91-2, *Publication Date: JANUARY 23, 1991*

| <ul style="list-style-type: none">• Chassis - Low Clearance Concerns - Low Profile Or Low Rider Models With 6.6L And 7.8L Ford Diesel Engines• Oil - Filter - 6.6L And 7.8L Ford Diesel - New Shorter Filter Available for "Low Profile Or Low Rider" Models | Article No. 91-2-14 |

MEDIUM/HEAVY TRUCK:

1987-91 CARGO SERIES, F & B SERIES, L SERIES

Figure 3 - Article 91-21-14

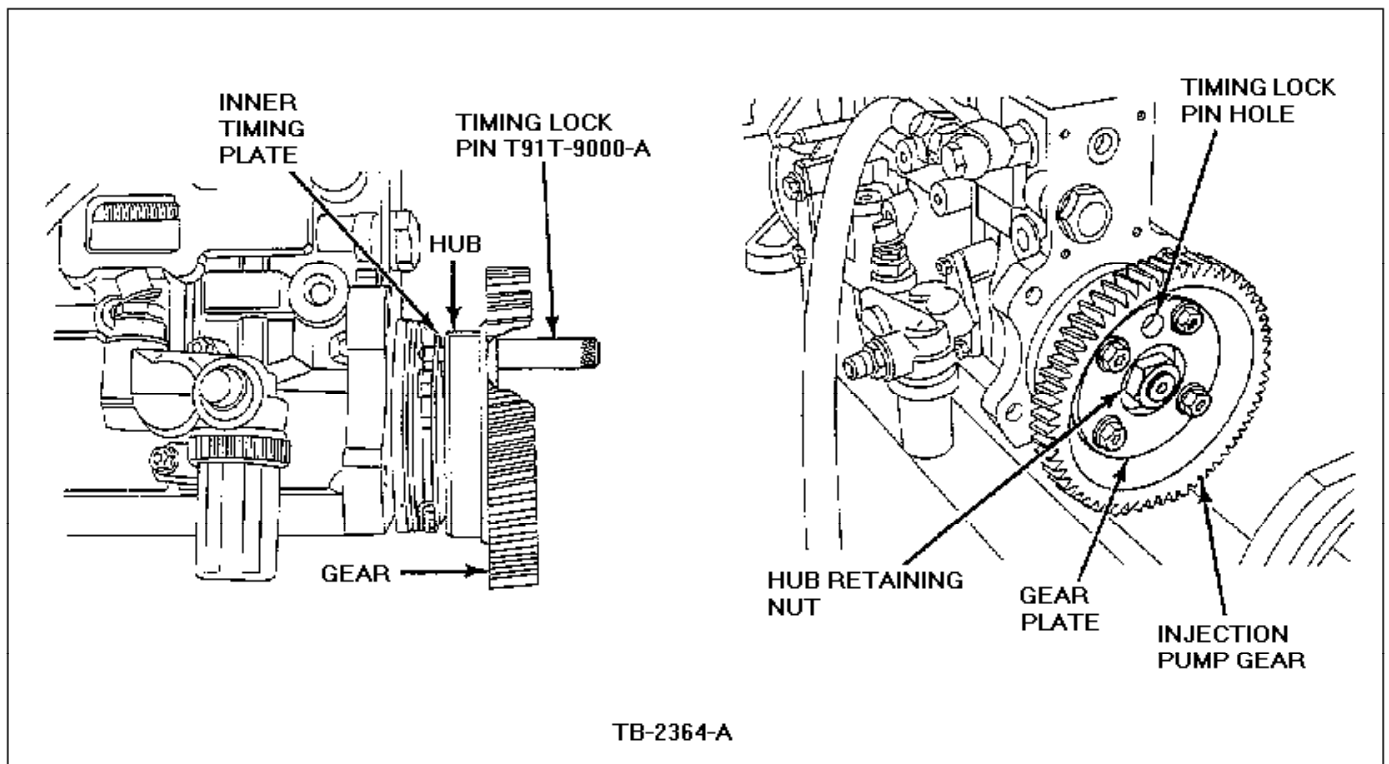
3. Insert the Injection Pump Aligning Pin (T91T-9000-A) through the gear plate, gear, hub and into the inner timing plate hole, Figure 3.

Figure 1 - Article 91-22-13

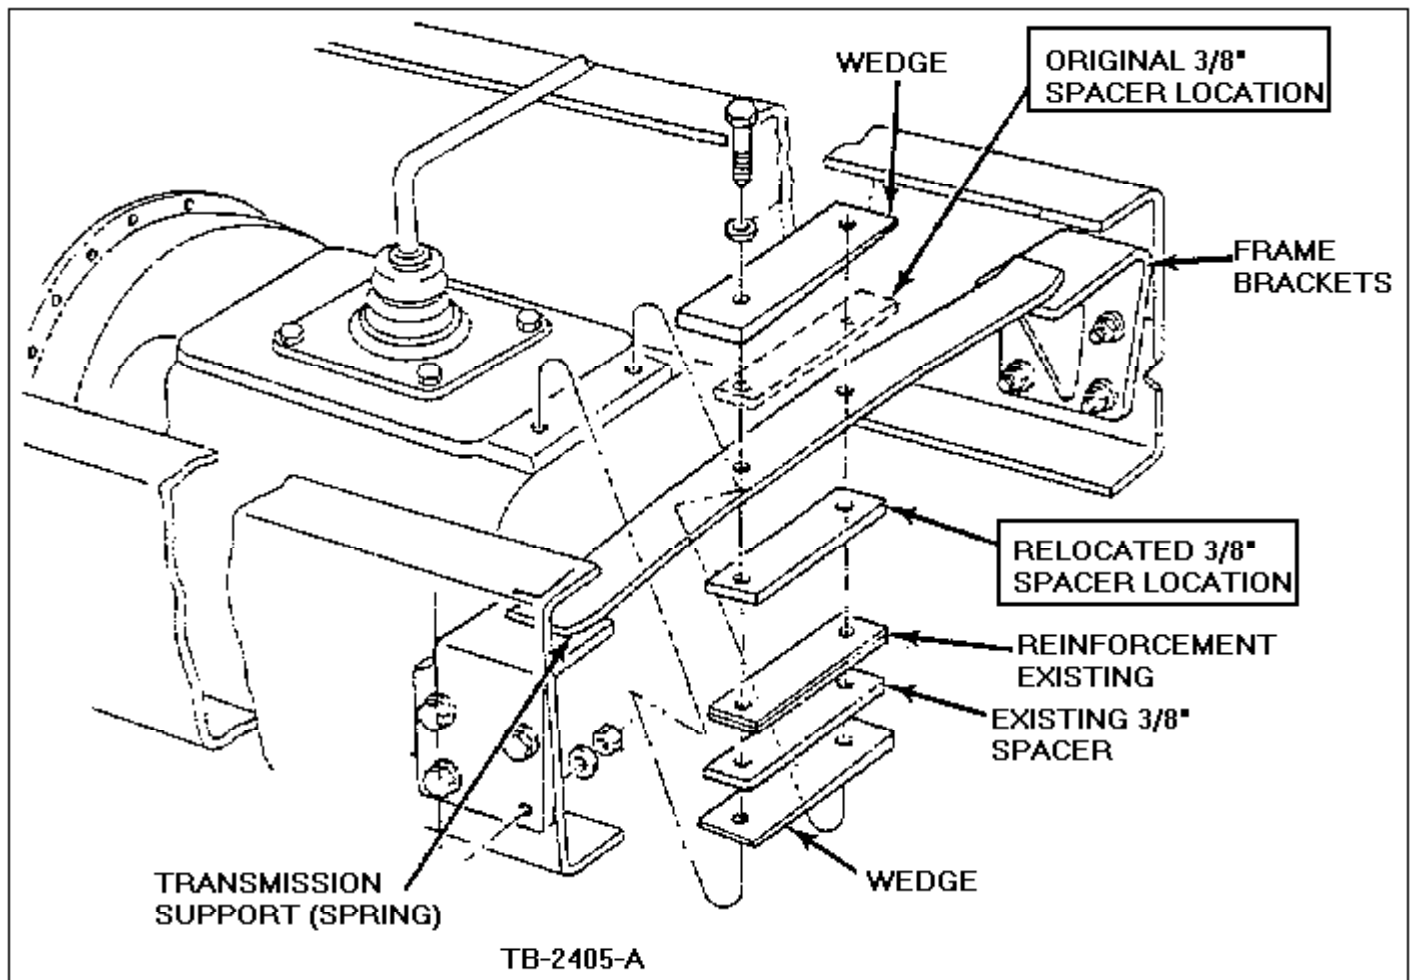
Refer to Figure 1 for the correct locations of the wedges and support component parts. The 3/8" (9.525mm) spacer should be under the the support spring as shown in Figure 1.

IF THE TRANSMISSION SUPPORT SPRING IS BOUND UP AND/OR BOTTOMING OUT, THE FRONT ENGINE SUPPORT SHOULD BE CHECKED FOR CORRECT ASSEMBLY.

Figure 1 - Article 91-25-20

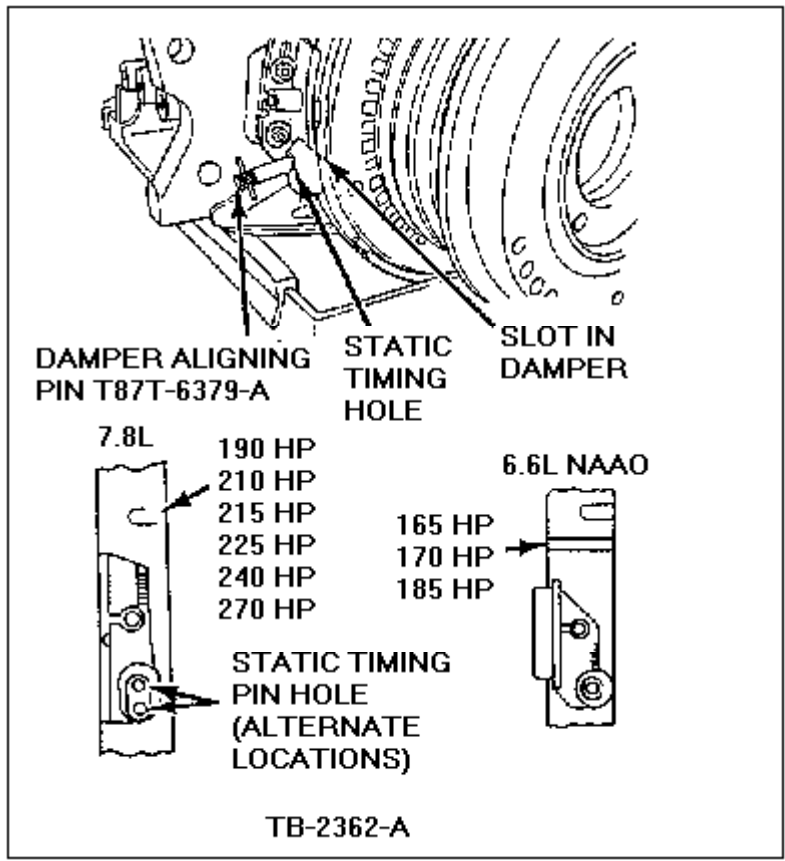
1. Remove the injection pump access cover and basket.
2. Rotate the engine clockwise.
 - a. Set engine at correct static timing angle with number 1 piston on the compression stroke.
 - b. Fit Damper Aligning Pin T87T-6379-A through the timing bracket into the correct crankshaft damper groove, Figure 1.

Figure 2 - Article 91-25-20

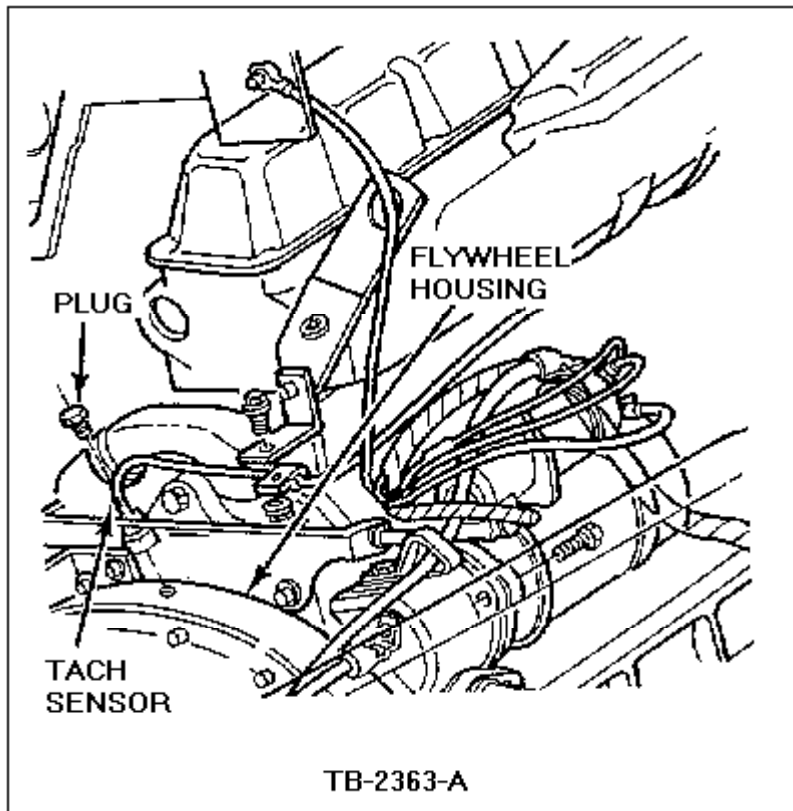
NOTE:
 WHEN UNABLE TO ACCESS THE FRONT DAMPER MOUNTING BOLT TO ROTATE THE ENGINE, REMOVE THE PLUG OR TACH SENSOR AT TOP OF FLYWHEEL HOUSING TO ROTATE FLYWHEEL RING GEAR WITH LARGE SCREWDRIVER, FIGURE 2.

Figure 3 - Article 91-25-20

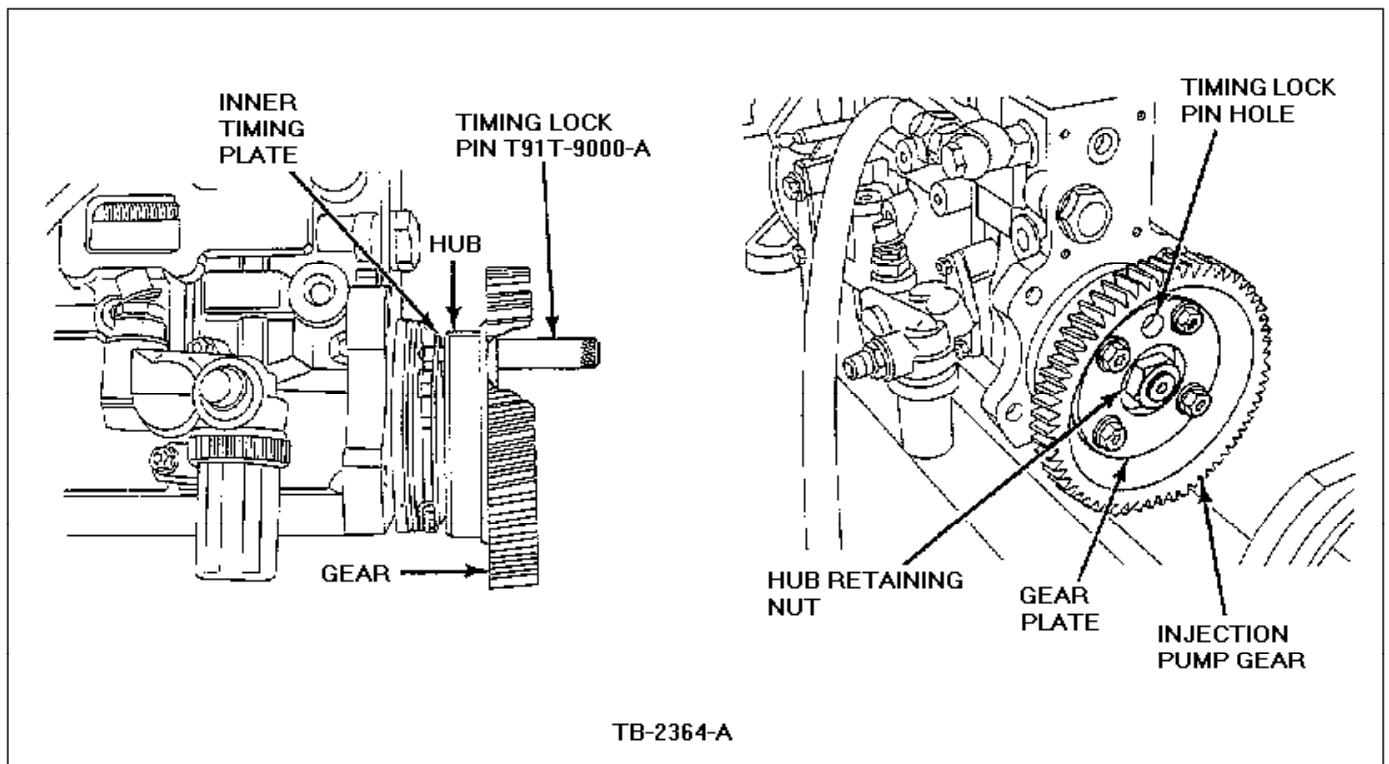
3. Insert the Injection Pump Aligning Pin T91T-9000-A through the gear plate, gear, hub and into the inner timing plate hole, Figure 3.
